INSTRUCTION TO SERVICE

ITS: 6006

SECTION:	231 Coolant System
WRITTEN BY:	Mike Pearson
SUBJECT:	Revise surge tank low coolant level sensor harness rework

Figure 1: Existing Surge Tank Low Coolant Derate Sensor

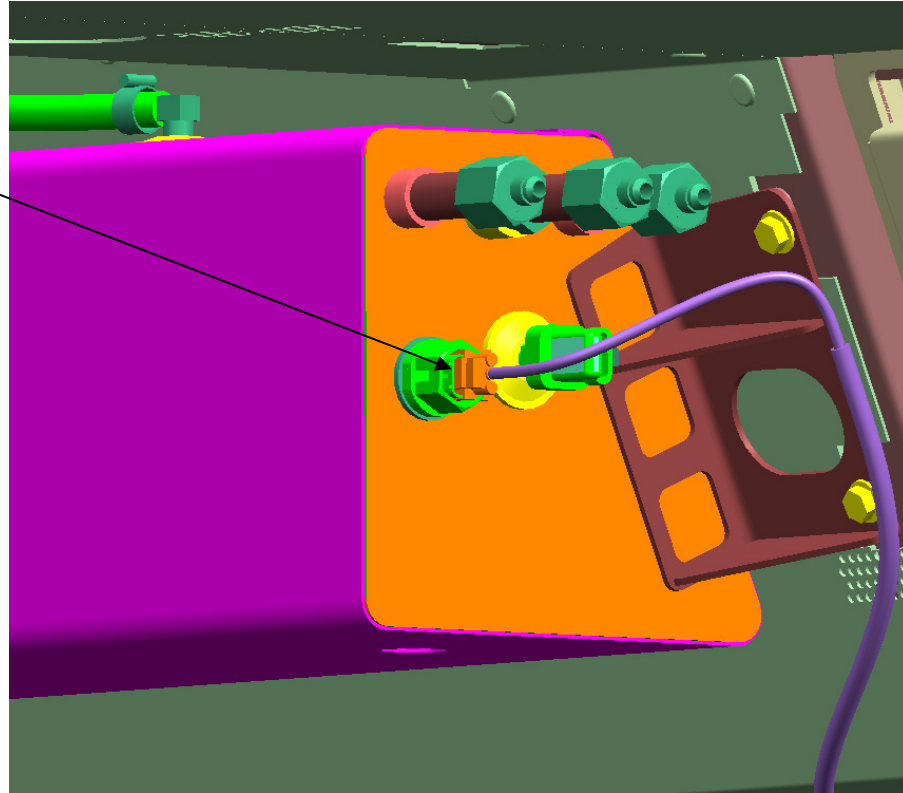
Rework existing
surge tank low
coolant derate
sensor harness

3. Disconnect the existing coolant derate sensor harness and examine the terminals on both the harness connector and the low coolant sensor for signs of corrosion. If corrosion is present then the sensor will need to be replaced with new sensor (NF P/N 473480).

4. Cut off the existing 3 circuit tower as close as possible to the connector of the disconnected harness and terminate each wire with the supplied terminal (NF P/N 108871) and wire seal (NF P/N 108872).

5. Insert wire 140EN46#2 (red) into supplied 3-pin shroud connector (NF P/N 104558) at cavity A (SIG).
6. Insert wire 140EN46#2 (black) into supplied 3-pin shroud connector (NF P/N 104558) at cavity C (GND).

7. Insert connector plug (NF P/N 102904) into supplied 3-pin shroud connector (NF P/N 104558) at cavity B.
8. Connect newly pinned shroud connector to supplied extension harness (NF P/N 584150).

9. Connect the new extension harness to the existing surge tank low coolant derate sensor harness.
10. After installation the connection between the main harness and the new extension harness and between the new extension harness and the low coolant sensor are to be wrapped with self fusing tape NF P/N 6411846. Approx. 12” of tape for each connection.
